From: Paul Cutmore <[REDACTED]>
Sent: 27 February 2025 06:09
To: TRANSPORTINFRASTRUCTURE
Cc: [REDACTED]
Subject: Objection to "Cambridge South East Transport (CSET) Order" dated January 2025
Attachments: Att1. 24-12-02 Initial Comments.doc; Att2. 24-12-06 CSET Comments from Cambridge Ramblers.pdf; Att3. Attachment to Ramblers email of 22-Jan-2025 CSET-11-DO4-00_Rights of Way & Traffic Regulation Plans - Volume 1 page3a.jpg; Att4. Appendix G Proposed landscape context plan-comment.jpg; Att5. 11-DO5-Page 6 CSET-11-DO5-00_Rights of Way & Traffic Regulation Plans - Volume 2.jpg; Att6. Gog Magog-Babraham link path.jpg

Objection to "Cambridge South East Transport (CSET) Order" dated January 2025, by Cambridge Group Ramblers' Association

Response to request to provide comments on Cambridge South East Transport Scheme, Transport and Works Act Order – draft order documents 1.1 18 Nov 2024, by Cambridge Ramblers. 6 Dec 2024.

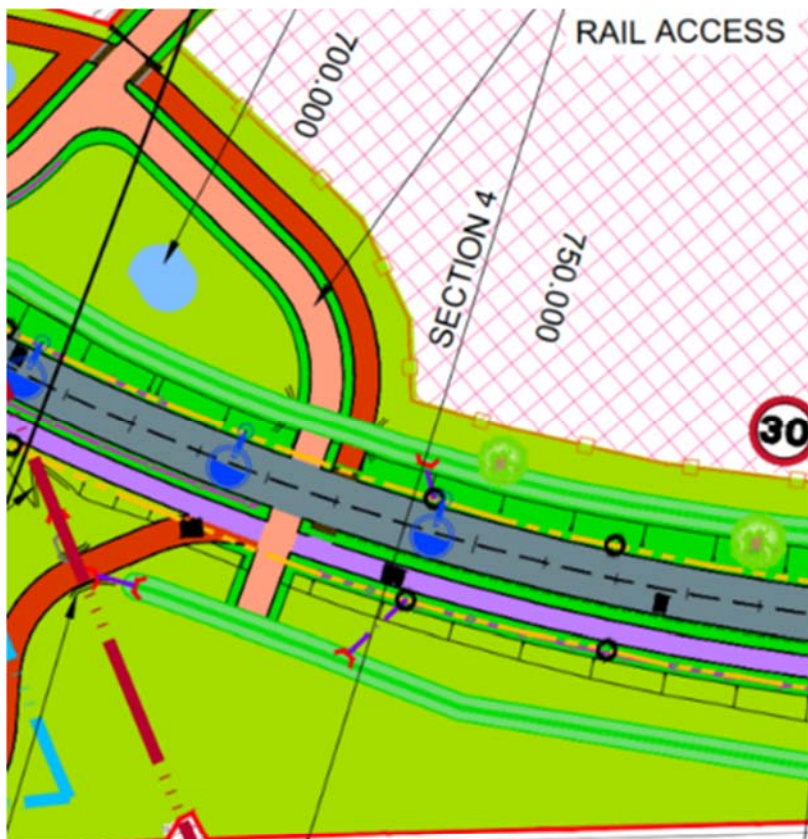
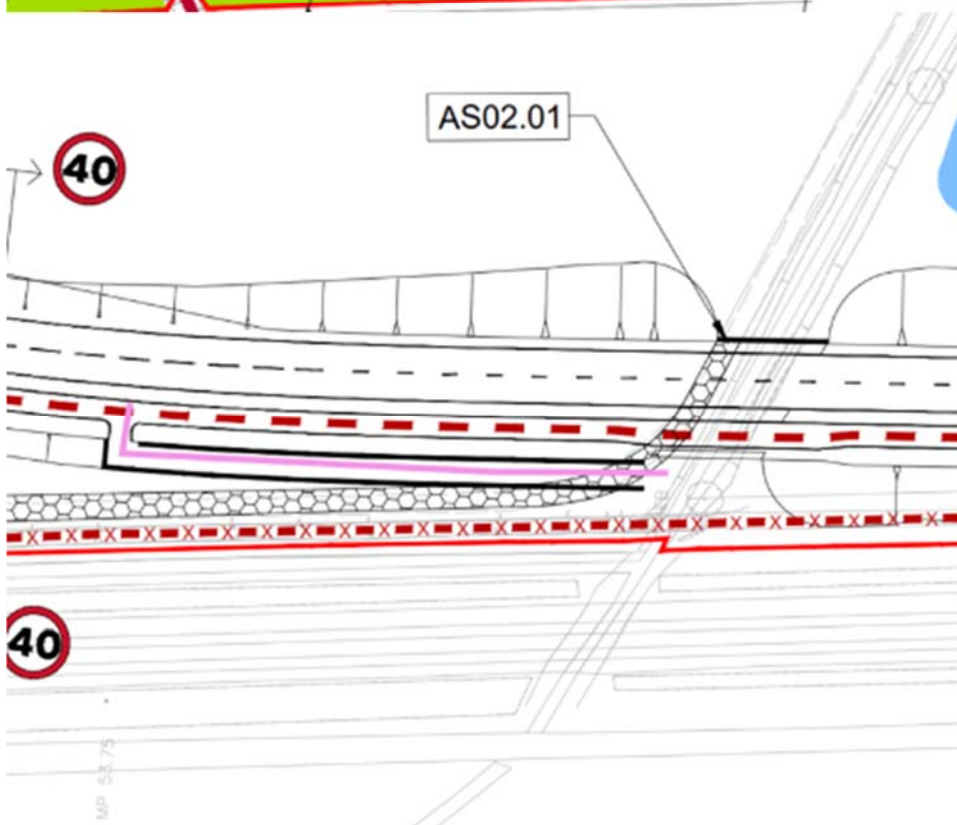
I note that on the previous version of this map (in CSET-11-DO4-00_Rights of Way & Traffic Regulation Plans - Volume 1 dated November 2024) the path from point B to Nine Wells was designated as "Proposed Pedestrian Private Means of Access", but this designation has been removed from the current map (January 2025). I don't understand the significance of this change - can you please explain? **The access is still there only the rights have been removed.**

I also note that the plans designate the path from A to C, via Nine Wells, as a "Temporary Diversion". This implies that after the temporary period, it will no longer be accessible. Is this the case? I assume that "diversion" in this context is referring to the DNA path which will be closed. In our opinion it should remain accessible after the temporary diversion; or in other words it should be a permanent diversion (of the DNA path). **The DNA path will be accessible during and after construction. The temporary diversion shown on plans is for DNA path and is for construction sequencing/phasing, so as to maintain accessibility for the DNA path during the construction period. Following completion of the guided busway, the DNA path will be diverted to emergency and maintenance access (active travel path) along the guided bus way route but will still be accessible.**

As far as I can tell, after the busway is built, walkers from Hobson's Park or the Shelfords can only access Nine Wells if they can cross the busway at points A, B and C. Is this what is planned and will these be safe crossing points for walkers? If not, how can walkers get to Nine Wells? Will the busway be fenced to prevent walkers crossing elsewhere? **An uncontrolled pedestrian crossing has been proposed between points A & B, please see the snip below and refer to drawing CSET-12-DP4B-00_Proposed Site Plans. An underbridge crossing is also proposed at point B and is shown on CSET-11-DO4-00_Rights of Way & Traffic Regulation Plans - Volume 1 (snip from plans below). Access Deterrent Planting has been proposed along the guided bus way route and the emergency and maintenance access track.**

Figure 1

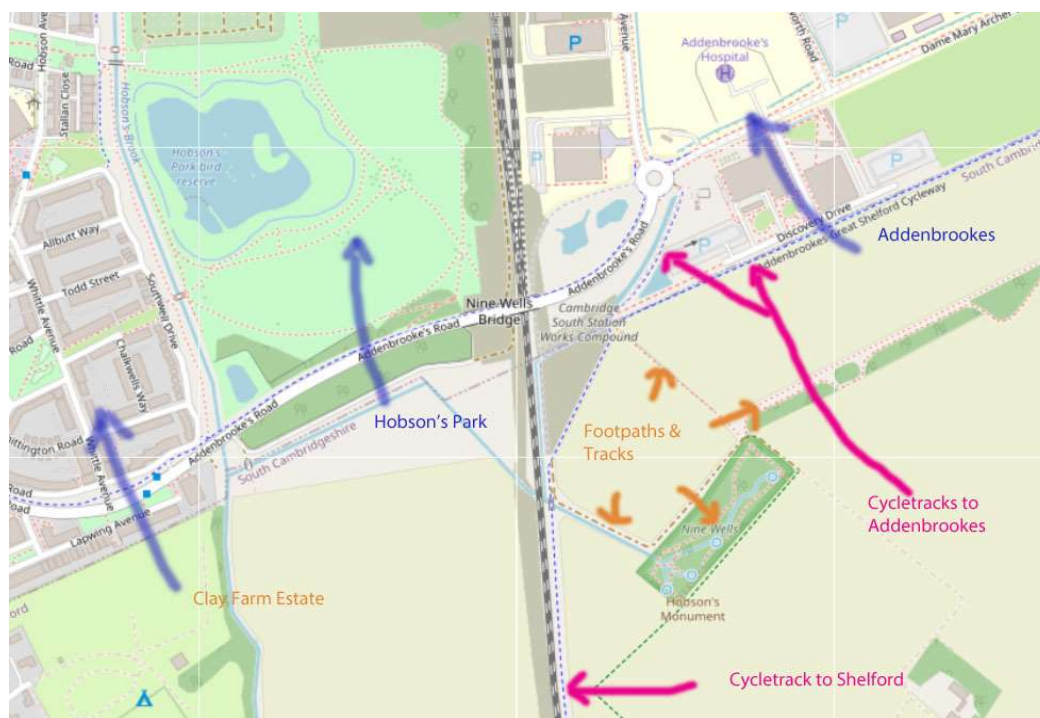
1.2 In particular, from looking at the Rights of Way plans in the draft TWAO (in particular CSET-11-DO4-00_Rights of Way & Traffic Regulation Plans) it appears that the proposal is to prevent walking between the Nine Wells Local Nature Reserve and both the Bio-Medical Campus and Shelford. Currently these connections are provided by the DNA cycletrack, but they do not appear to be reflected in the busway plans in the draft TWAO. We trust that this is not a deliberate policy but merely results from the lack of impact assessment of the needs of walkers.

1.3 If left to stand as proposed, it would mean that Bio-Medical Campus users would be denied access to the Local Nature Reserve. It would also mean that leisure and active travellers between Shelford and Cambridge would be forced to give up the rural Nine Wells route and solely walk on roads and tarmac. In addition there would be no access to Nine Wells from Hobson's Park or the Clay Farm housing estate.

1.5 The following map (based on OpenStreet Map) shows the footpaths and tracks currently used and which would become unavailable if the proposals were put into practice.

Figure 2

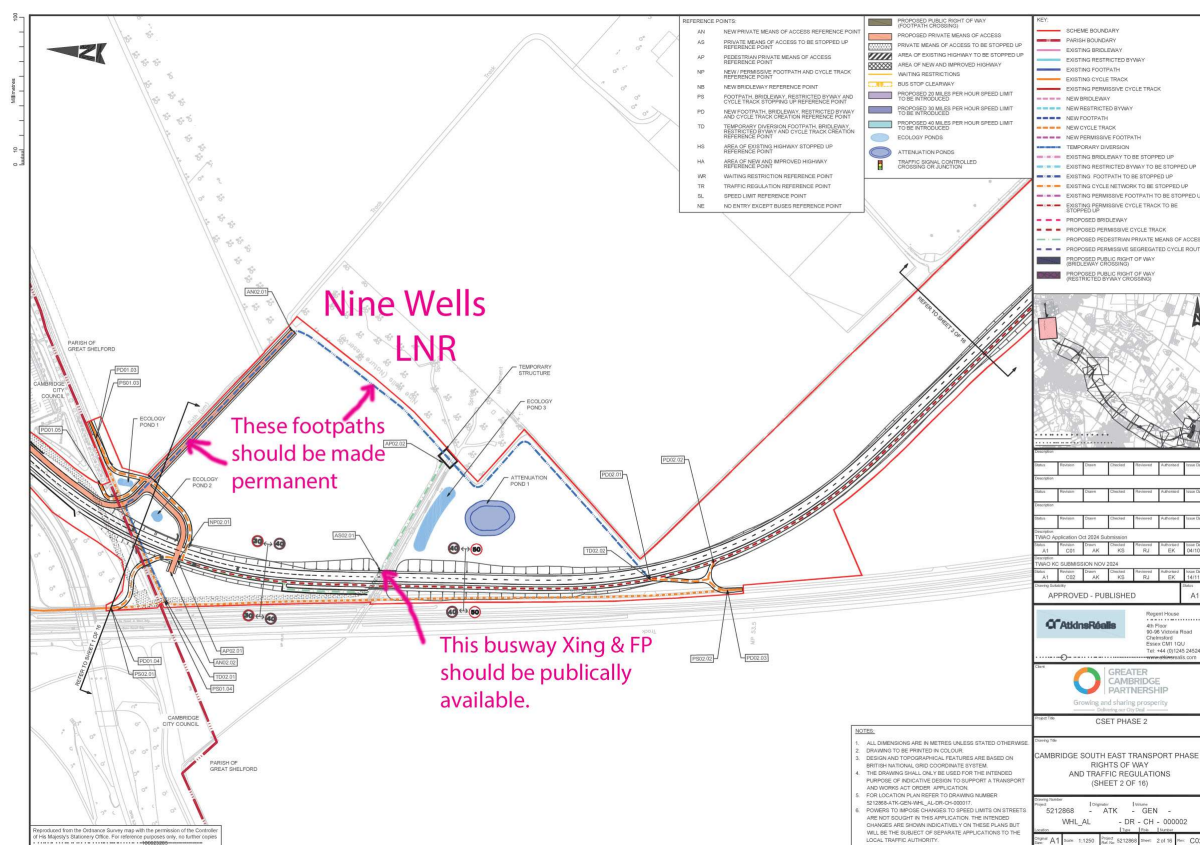
1.7 This matter must be rectified. We make two suggestions in our comments on the following map

Figure 5

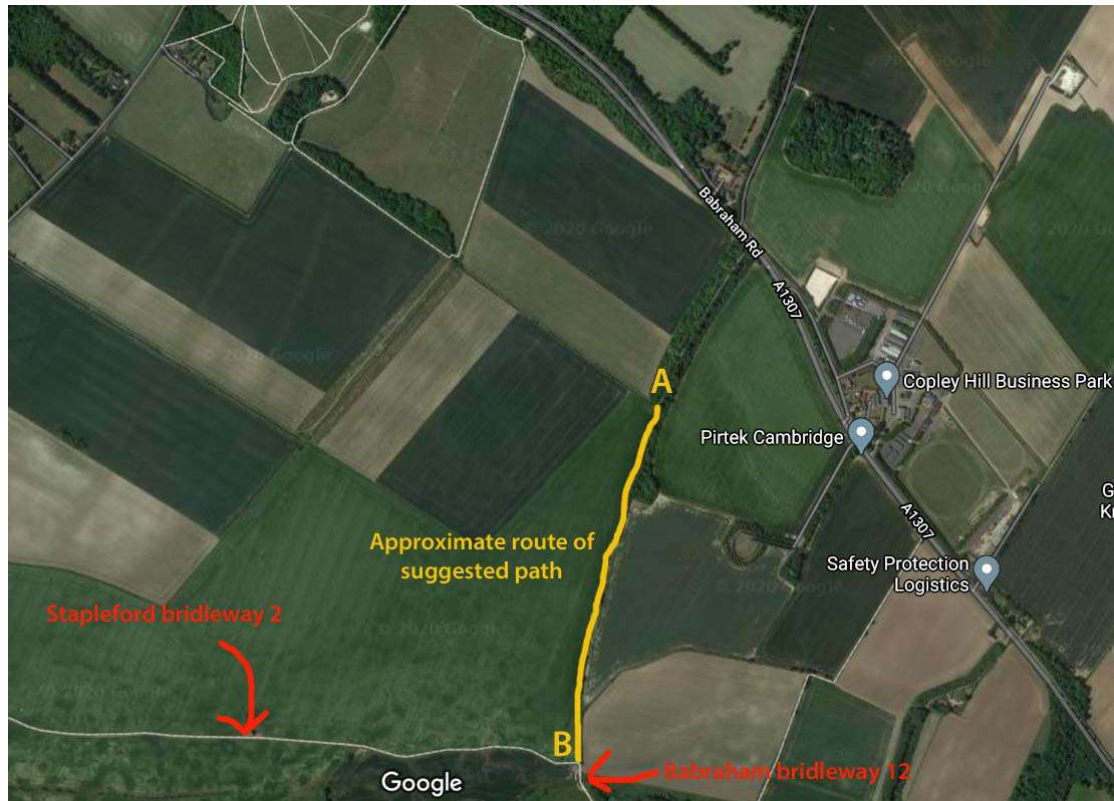
D. Additional footpath. In 2020 we suggested a link path between Babraham bridleway 12 and Gog Magog - see attached map Att6. We are disappointed, rather than specifically objecting, that it has not been included in the CSET Order Plan. We nevertheless urge the CSET project to take this opportunity to improve the footpath network in the neighbourhood.

5.1 **Additional footpath.** In the 2020 consultation we were asked for any suggestion on footpath improvements. We made the following suggestion for a link path between Babraham bridleway 12 and Gog Magog.

Drawing Title: CAMBRIDGE SOUTH EAST TRANSPORT PHASE 2
RIGHTS OF WAY
AND TRAFFIC REGULATIONS
(SHEET 2 OF 16)

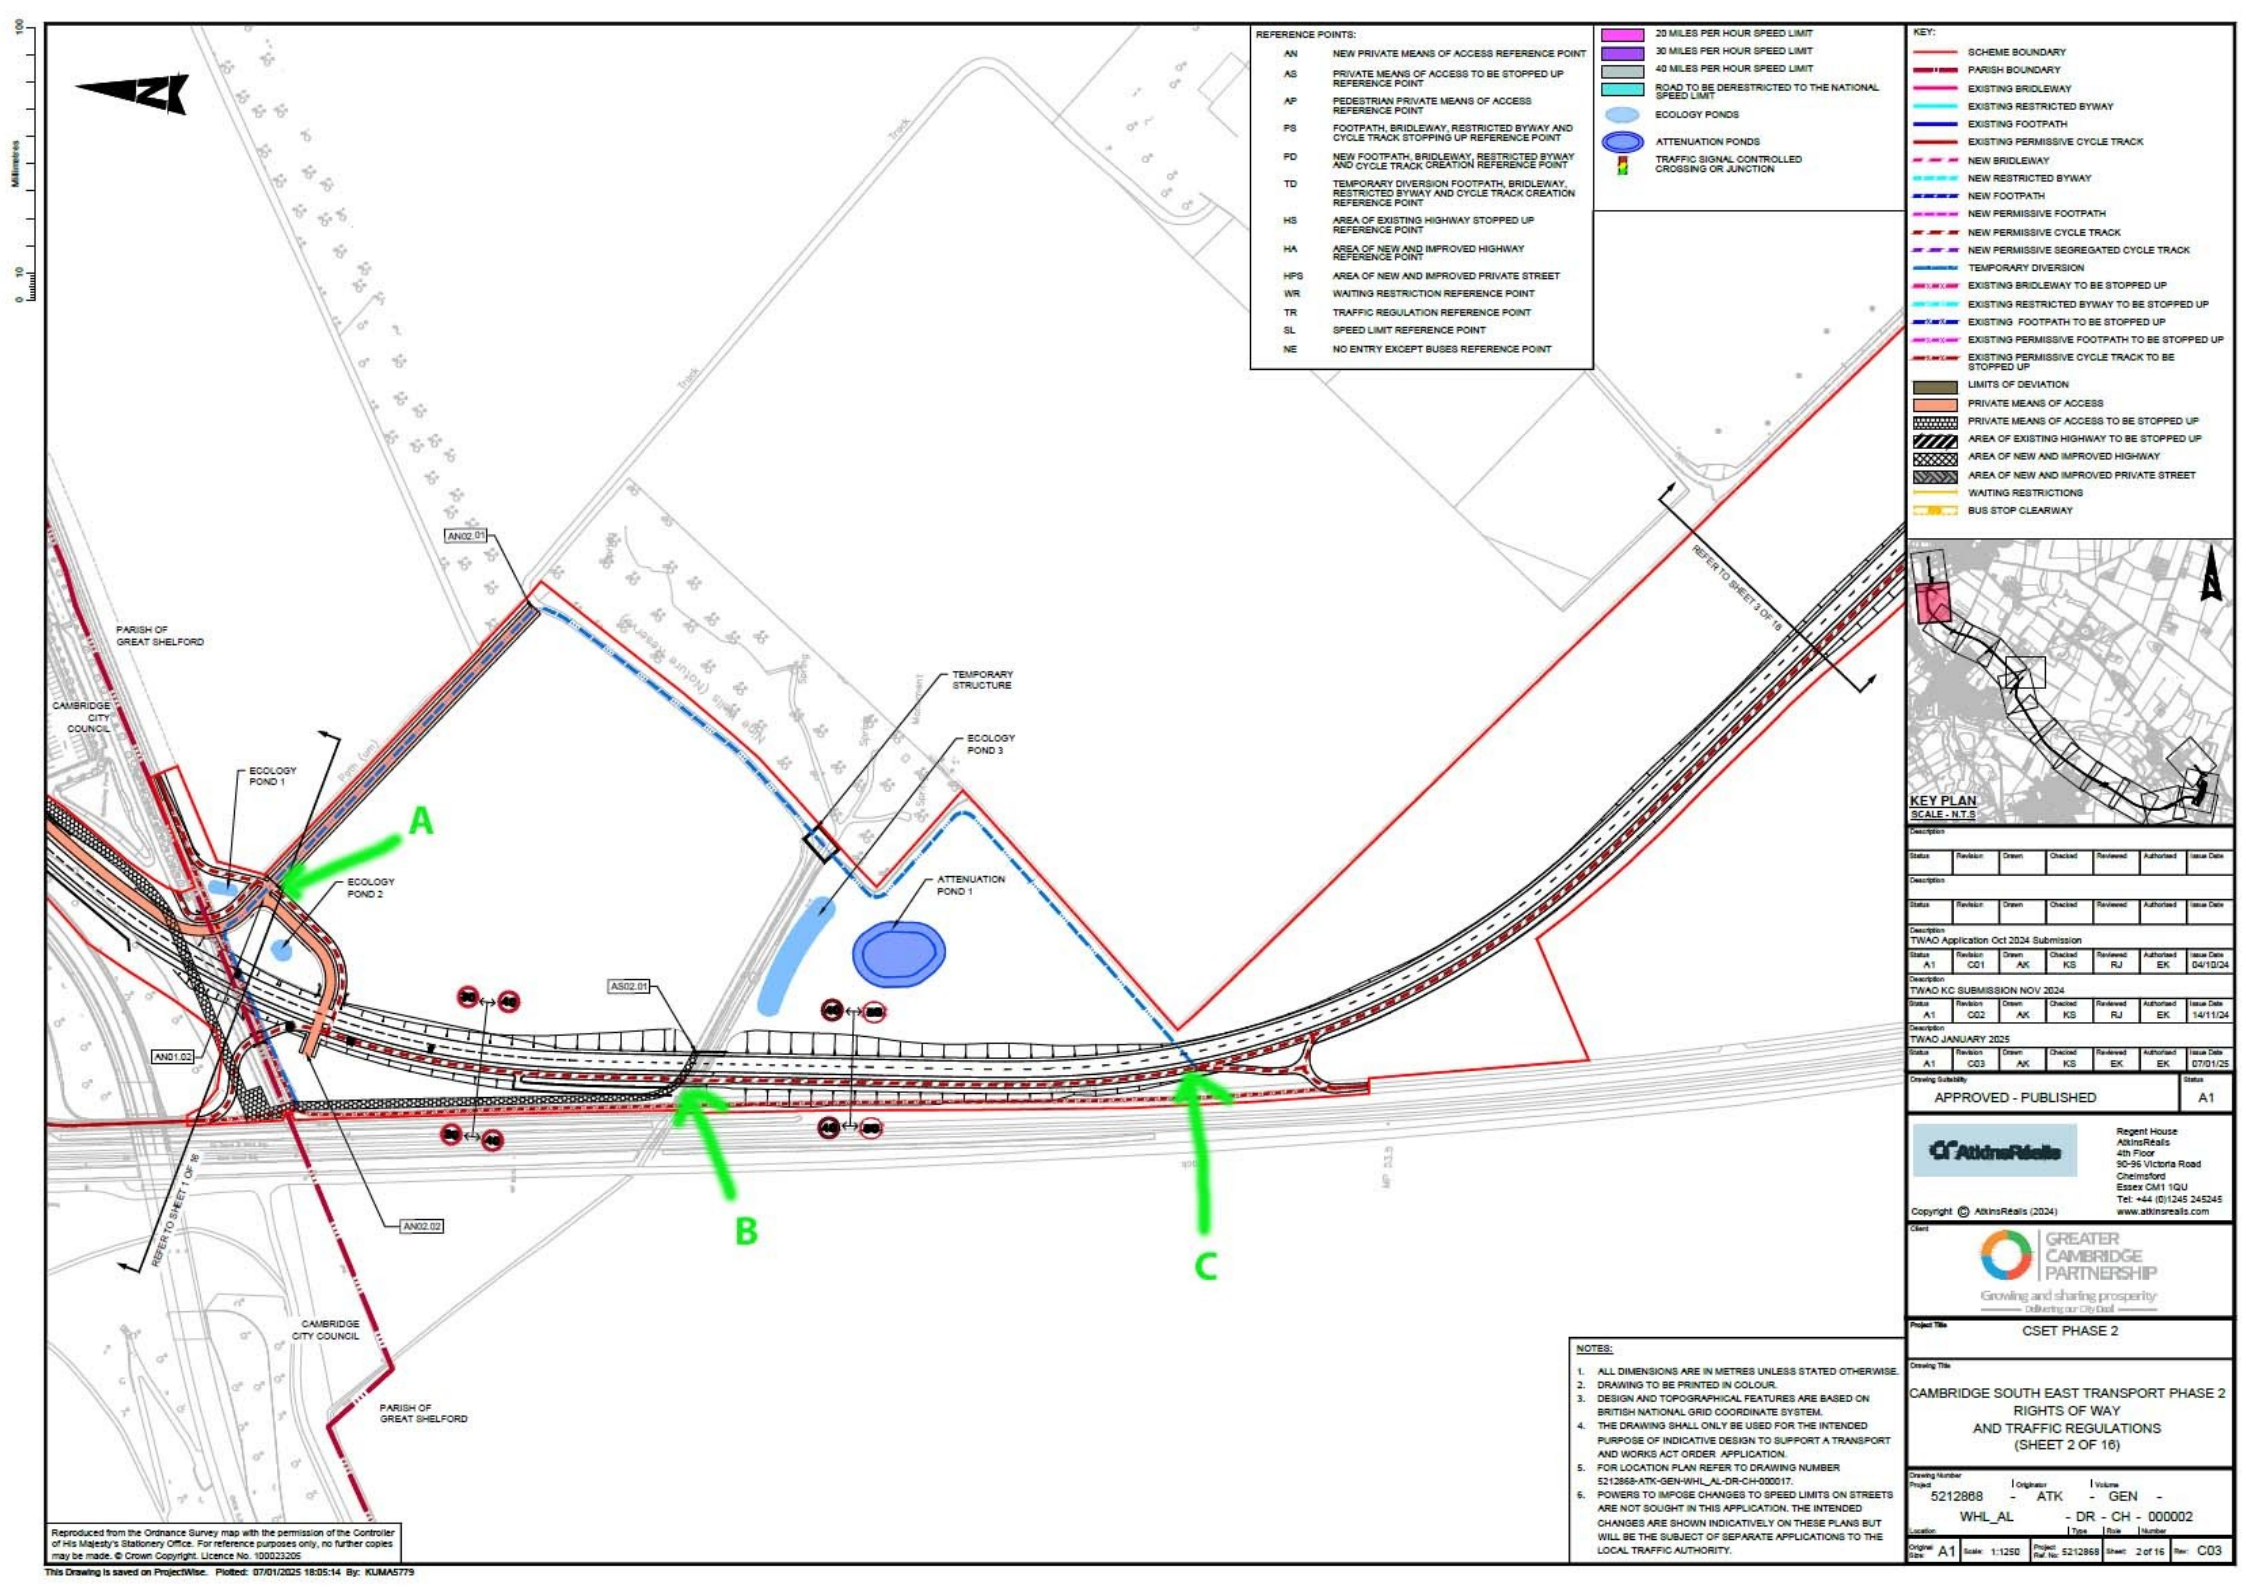
However, in the proposed design, it appears that the footpath (FP 12/3) now needs to cross 3 or 4 roads. This appears to be both unsafe and inconvenient for both footpath users and vehicle drivers. We suggest that the design should revert to a much narrower crossing, two roads only, which would reduce the length of any extension to the bridge (if implemented) or width of pedestrian crossing. If a footbridge is not constructed/extended to cross the Hub access roads, then pedestrian controlled crossings are required. See specific comments on attached map Att5.

3.2 However, in the proposed design, it appears that the footpath (FP 12/3) now needs to cross 3 or 4 roads. This appears to be both unsafe and inconvenient for both footpath users and vehicle drivers. We suggest that the design should revert to a much narrower crossing, two roads only, which would reduce the length of any extension to the bridge (if implemented) or width of pedestrian crossing. See comments on below map.
